RE: EROSION PROTECTION DESIGN CONCERNS IDENTIFIED AT RECENT SITE
VISIT (TAC NO. L52459) - *Docket 40-8907*

On behalf of United Nuclear Corporation (UNC) enclosed is the engineering evaluation and proposed reclamation alternatives for the areas of concern identified at the Church Rock Mine Tailings Impoundment in the memorandum from the NRC dated January 7, 2003.

**EROSION AND SEDIMENTATION EVALUATION AT THE
UNITED NUCLEAR CORPORATION
CHURCH ROCK URANIUM MILL TAILING SITE**

DRAWING TITLE:
FACILITIES MAP AND LOCATIONS OF SEDIMENT DEPOSITION

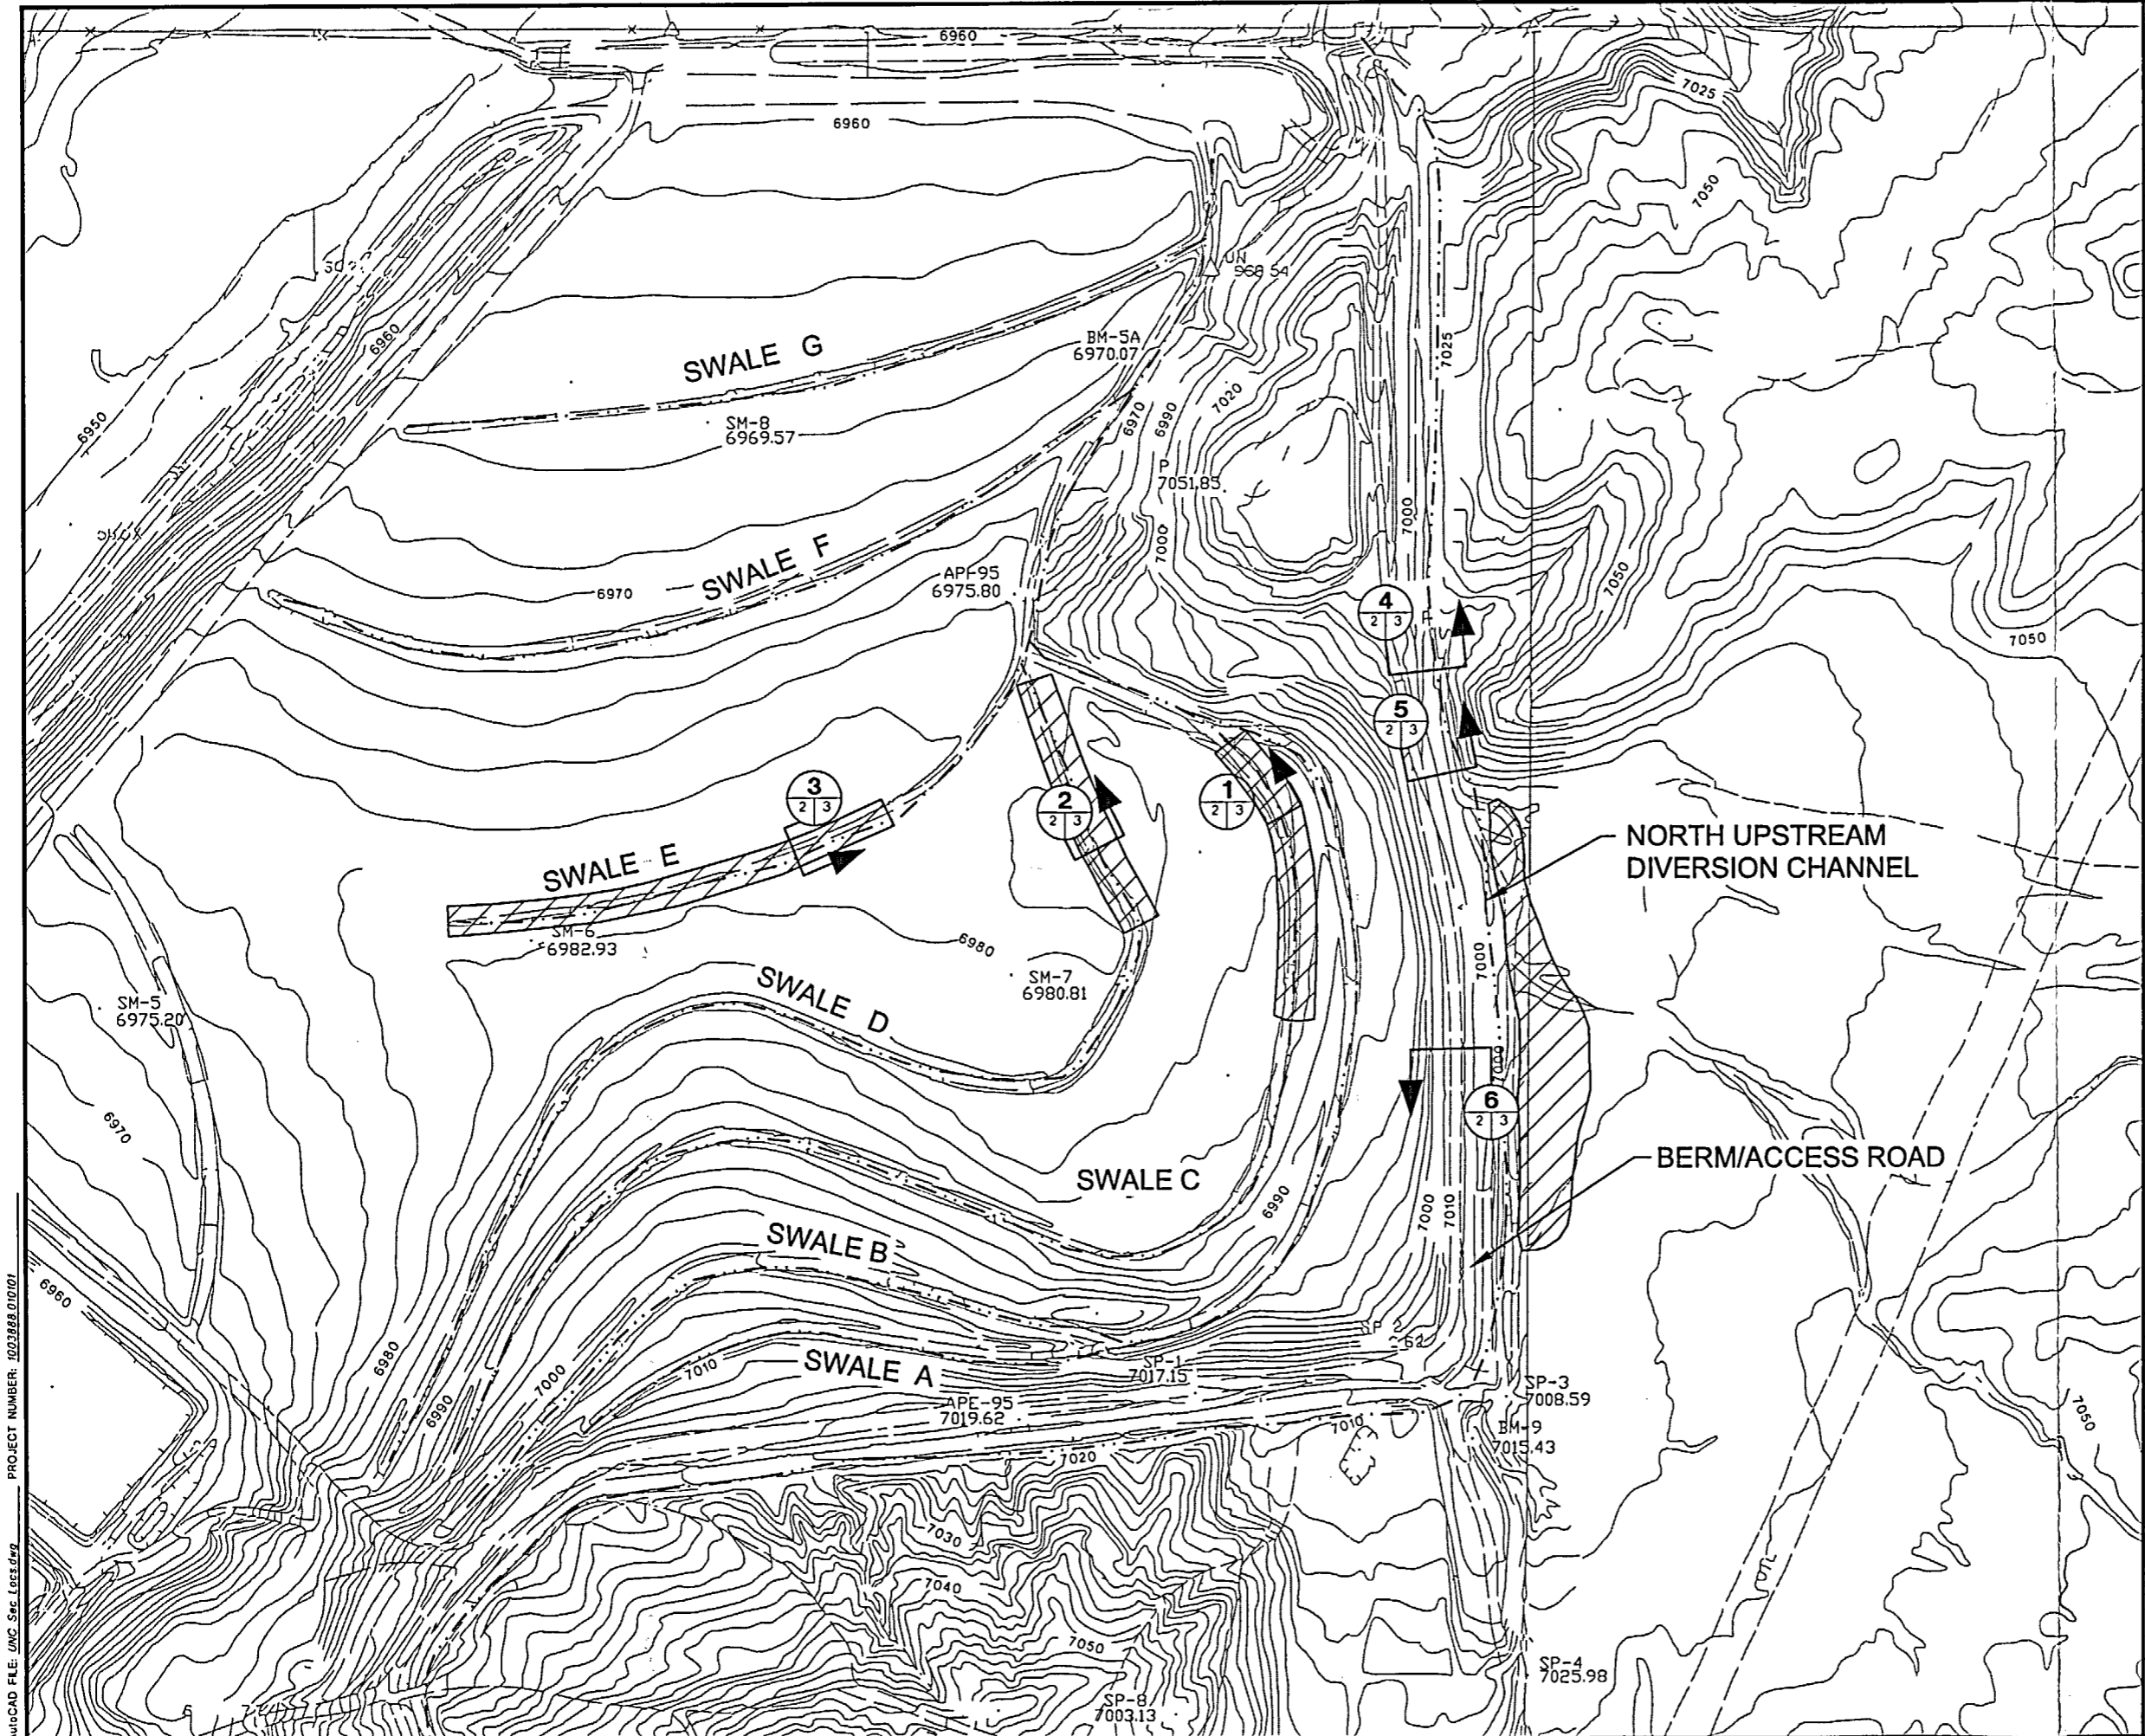
A visual inspection of Branch Swales A through G was performed to determine the impact of sediment in each swale. Sedimentation was noted in the lower portions of Swales C and D and in the majority of the length of Swale E as shown on Figure 1. Cross sections were measured in the areas of sedimentation and the existing bed slope was measured at each cross section location. The locations of cross sections for the branch swales are shown on Figure 2. These cross sections were used to estimate sediment volumes and calculate available flow capacity.

Currently Swale E will not pass the design PMF discharge, and at the current rate of windblown sedimentation in Swales C and D, it is likely that these swales will also eventually be limited in flow capacity. None of the swales currently has the ability to flush sediment during smaller, more frequent storms such as the 10-year event. The NRC inspection report stated that removal of sediment from the swales using heavy equipment would be difficult and would cause damage to the lining with the small size of the riprap that currently lines the swales. MWH agrees that removal of the sediment with heavy equipment would damage or disturb the channel lining.

MWH recommends that control measures for windblown sediment, such as constructing small rock berms upwind of the swales in order to deposit windblown sediment before it can deposit in the swales be used. This rock berm would be placed on the cover surface so that it would cause deposition of windblown sediment on an area of the tailings cover that could be accessed by equipment for more cost effective removal. UNC will complete removal of the windblown sediment from the swales, design and construct rock berms to manage wind blown sediment deposition, and bond for removal of windblown sediment deposited by the berms on an periodic ongoing basis.

1 SWALE C CROSS-SECTION
 (BED SLOPE = 0.49%)
 HORIZONTAL SCALE
 0 2 4'
 VERTICAL SCALE
 0 2 4'

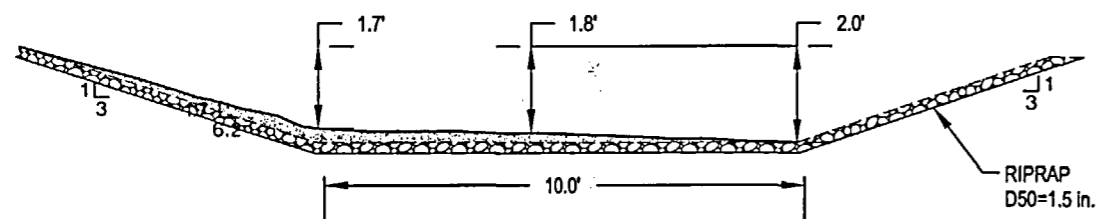
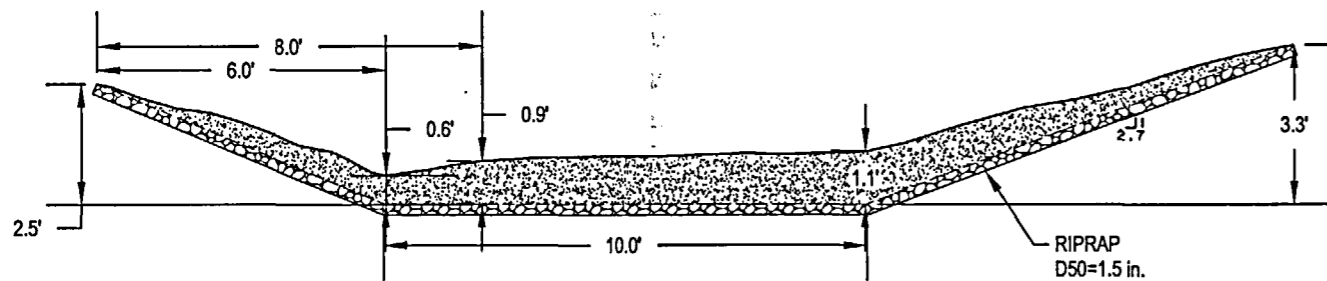
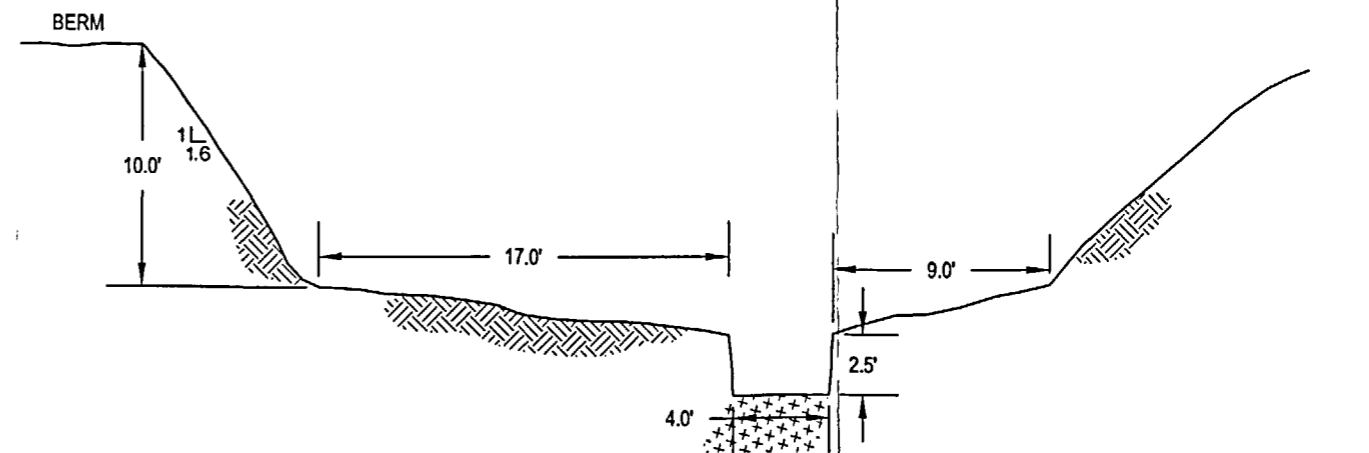
Sedimentation in the lower portions of Swales C and D is occurring on the left side slope of the swale, looking downstream, with sediment depths decreasing across the channel bottom. On the right side slope there is little or no deposition. The location of deposited sediment within each cross section is shown on Figure 3.

A profile of the sediment depth was measured at each cross section to be used for estimation of deposited sediment volumes of approximately 100 tons in Swale C and 60 tons in Swale D. Sedimentation in Swale C is shown in Photo 1. Sedimentation in Swale E is generally greatest on the right sideslope (looking downstream), with dunes in excess of one foot in depth present in the upper two-thirds of the swale. The volume of sediment in Swale E was estimated to be approximately 760 tons using sediment depths measured during the field analyses. A typical cross section of deposited sediment is shown on Figure 3, and Photo 2 shows the sedimentation in Swale E.

Swales C and D currently have the capacity to pass the PMF discharge with the existing sediment in the swales, however Swale E would be overtopped. The capacity of Swale E is approximately 37 cfs, slightly less than half of the PMF flow rate.

4 NORTH UPSTREAM DIVERSION CHANNEL PILOT CHANNEL CROSS-SECTION
 (BED SLOPE = 0.34%)
 HORIZONTAL SCALE
 0 4 8'
 VERTICAL SCALE
 0 4 8'

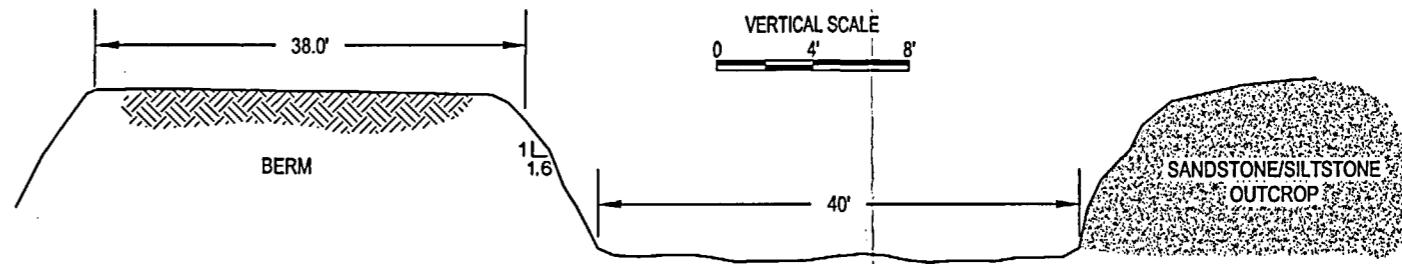
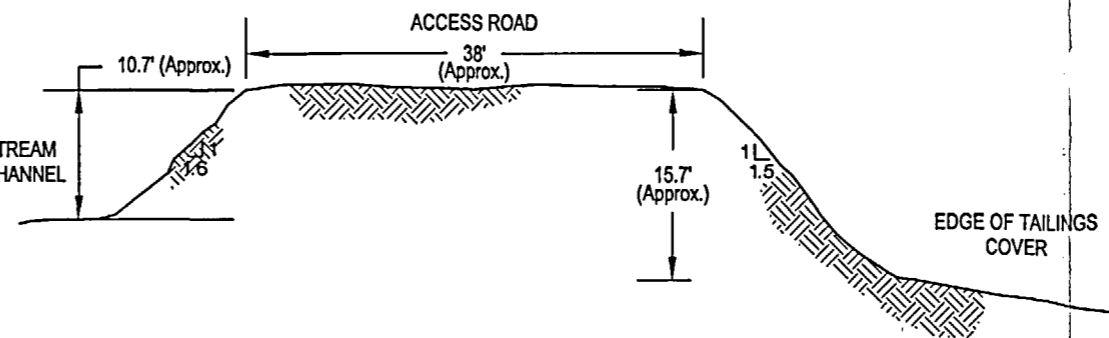
The North Upstream Diversion Channel was inspected to characterize sedimentation noted by the NRC. Downstream of the access road/berm the channel was constructed by cutting through a small ridge, and the channel has incised down to the sandstone bedrock as shown on Photo 3. Just upstream from this reach the channel bed consists of deposited sands and silts with a small pilot channel scouring into the main channel bed. The pilot channel is shown on Photo 4. Just upstream from the pilot channel the bottom width increases to approximately 40 feet, with a well-defined flow path approximately 6-8 feet wide as shown on Photo 5. Between this reach and the pilot channel, a headcut has developed to a depth of approximately 2-3 feet. Cross sections were surveyed immediately downstream of the headcut at the pilot channel and upstream of the headcut where the channel bottom width increases. The locations of these North Upstream Diversion Channel cross sections are shown on Figure 2.

Hydraulic analyses for the pilot channel portion of the North Upstream Diversion indicate that smaller return period storms, such as the 5-year event, will have sufficient depth of flow and velocity to periodically flush sediment. For the steeper, wider section just upstream of the pilot section, shear stresses from smaller flow events will be sufficient to detach sediment, however it will take storms equal to or greater than the 10-year event to mobilize and flush the sediment.

The analyses performed on the North Upstream Diversion Channel indicate that sediment is being mobilized and flushed during frequent, smaller storms. The NRC's inspection report noted that deposited sediment adjacent to the berm/roadway was being stabilized by vegetation. Though there is established vegetation in the area, the presence of a 2- to 3-foot headcut in the natural channel adjacent to the north end of the roadway demonstrate that runoff still has the potential for scouring

the sandy, silty sediments. Additionally, the slope of the channel bed below the headcut is flatter than the slope of the channel upstream of the headcut. The headcut will continue to move upstream and will continue to remove accumulated sediments as demonstrated by similar naturally occurring headcuts in other ephemeral stream channels. Thus, in response to the NRC's comments, the preceding analyses have demonstrated that long-term sedimentation in the North Upstream Diversion Channel will not be problematic.

PROJECT: **CHURCH ROCK SEDIMENT EVALUATION**
DRAWING TITLE: **BERM/ACCESS ROAD RIPRAP PLACEMENT DETAILS**

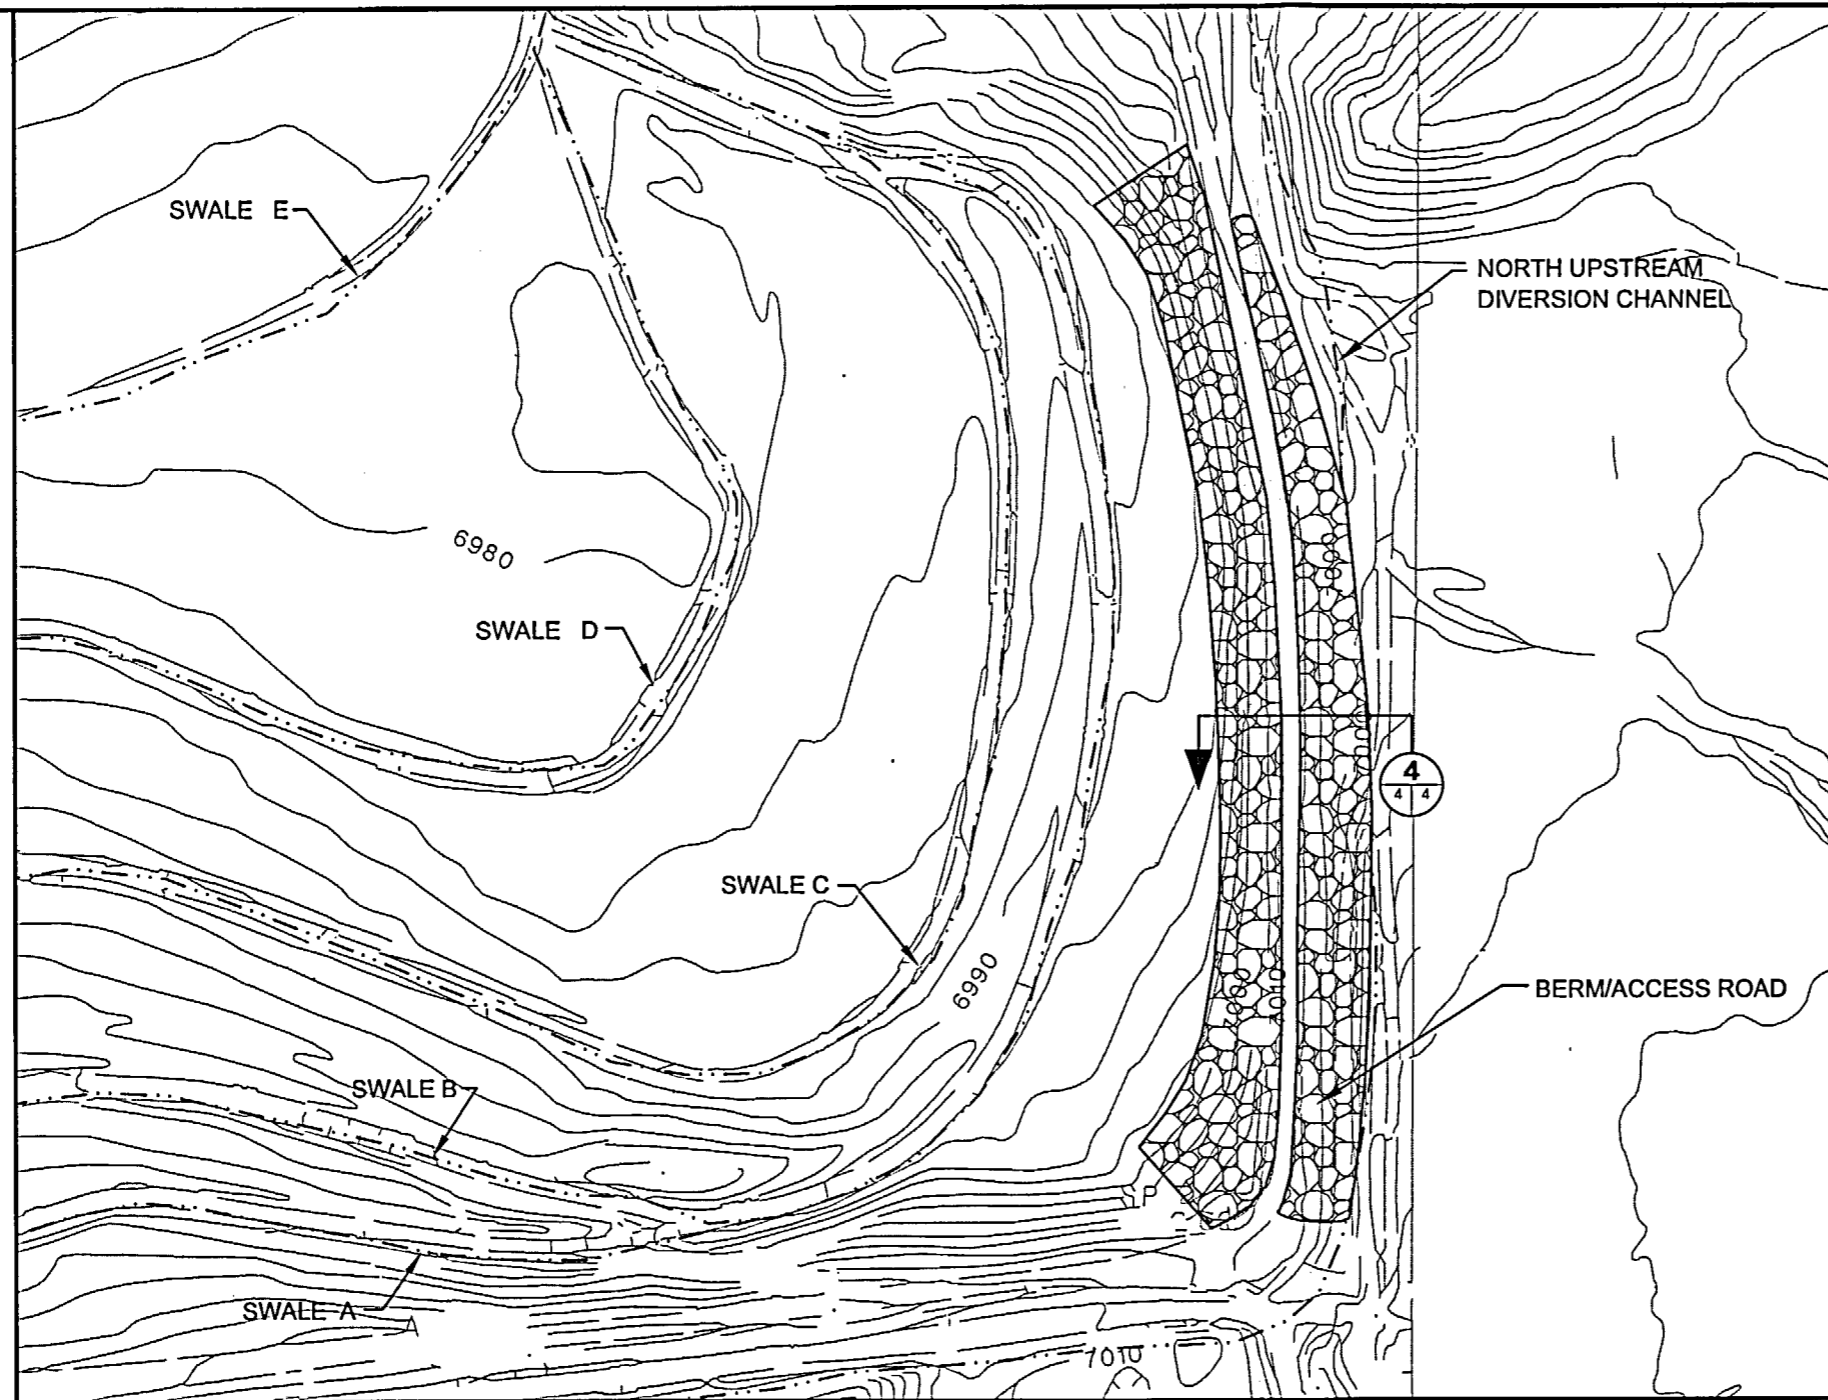
Erosion on the berm is limited to minor rilling on both the east and west embankments, with only a few areas of localized minor headcutting occurring where runoff from the road becomes concentrated. Rilling on the berm sideslope is shown on Photo 6. A cross section was surveyed in approximately the center of the berm to measure the existing embankment slopes, top width and height of the berm above the existing ground to the east and west. The berm sideslopes were measured to be approximately 1.6H:1V and 1.5H:1V on the east and west sides, respectively, and the top width was measured to be approximately 38 feet. The berm cross section is shown on Figure 3.

Degradation of the berm was found to be limited to minor rilling with only a few small headcuts present along the entire length. Placement of a layer of riprap over both the east and west embankments will prevent further erosion.

Riprap for the embankments was sized to be stable under the PMF using the Abt and Johnson Method as detailed in Appendix D of NUREG-1623. The peak discharge was calculated assuming that all of the runoff from the top of the road would be concentrated into a flow path on only one of the embankments and would have a width of 100 feet. Although the runoff would likely occur as

sheet flow over the embankment, a concentration factor of 3 was used corresponding to channelized flow. Using these assumptions, a minimum D_{50} of 1.2 inches would be required to prevent further erosion of the embankments.

Placement of riprap on the east and west embankments of the access road will stop the minor rilling and headcutting that is currently occurring and will prevent future erosion. The minimum required D_{50} of the riprap is 1.2 inches, and it should be placed in a layer thickness of at least 3 inches. If larger riprap is used, it should be placed with a thickness of at least two times the D_{50} . Any riprap that is placed should be keyed into the toe of the slope a minimum of 3 feet to prevent scour at the toe and undercutting of the riprap. The extent and details of riprap placement are shown on Figure 4. Riprap used on the embankments will be sized to meet the gradation specifications shown in Table 4.
